Proposed Revisions to a Standard Plans Index

Index Number: 455-030

Index Title: 30" SQUARE PRESTRESSED CONCRETE PILE

Reverted to the previous version of the Standard.

LAST REVISION 07/01/22	REVISION	DESCRIPTION:		FY 2023-24 STANDARD PLANS	30" SQUARE PRESTRESSED CONCRETE PILE	INDEX 455-030	SHEET 1 of 1
---------------------------	----------	--------------	--	--------------------------------------	---	------------------	-----------------

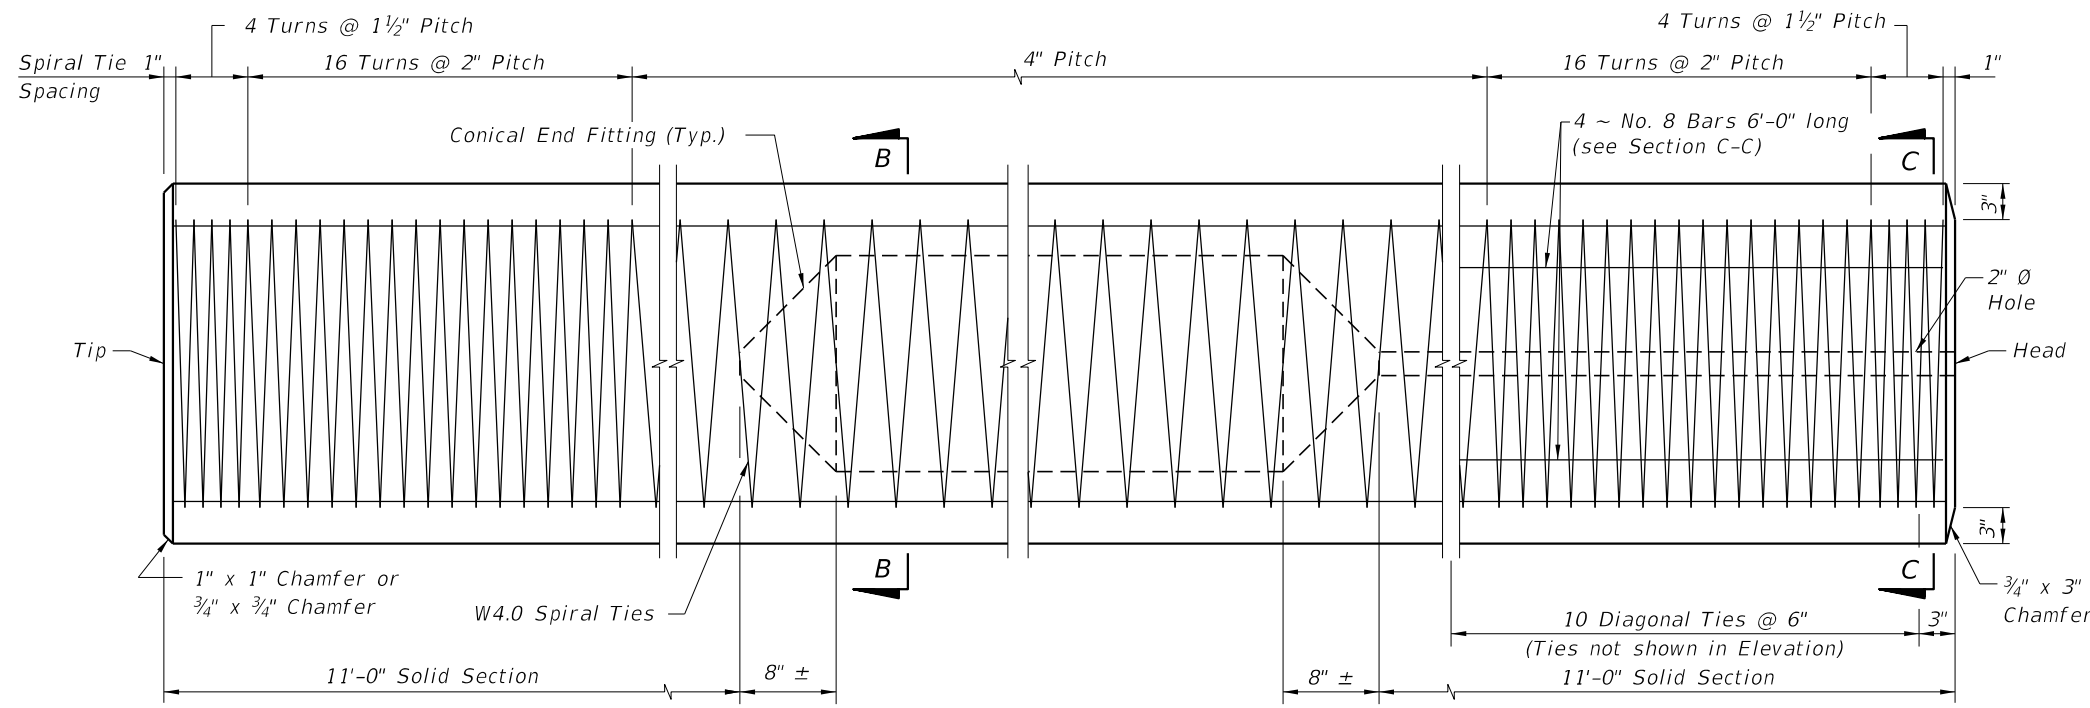
- Work this Index with Index No. ~~20600~~ - Notes and Details for Square Prestressed Concrete Piles and Index No. ~~20601~~ - Square Prestressed Concrete Pile Splices.

455-002 → 455-001

- Work this Index with Index 455-001 - Notes and Details for Square Prestressed Concrete Piles and Index 455-002 - Square Prestressed Concrete Pile Splices.
